Service Bulletin

Subject: Rattle/Squeak Noise and/or Rear of Center Console Loose

Models: 2013 Cadillac ATS
Vehicles Built Prior to May 10, 2013

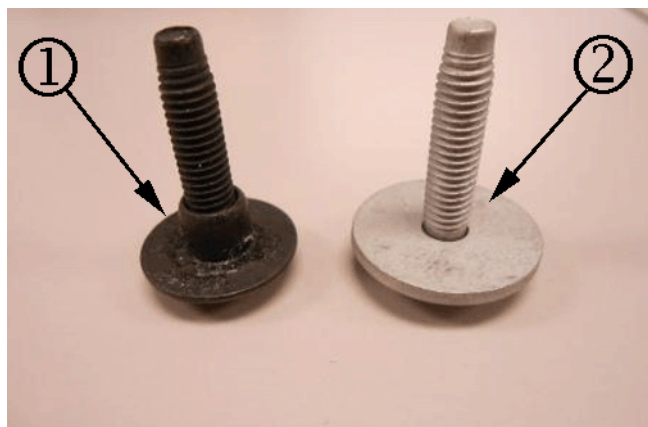
This may be due to a design change with the rear of the center console that may cause the two rear attaching bolts to bottom out before being fully secured.

Note: (1) is the bolt used during production, (2) is the revised bolt being used

Replace both the right and left rear side console bolts, as shown in the illustration above, with the revised bolt listed in the Parts Information below. **DO NOT** replace the front console bolts. They are not affected.

Tighten: Tighten the bolts 9 Y (80 lb in).

Part Number	Description	Qty
11609685	Bolt	2
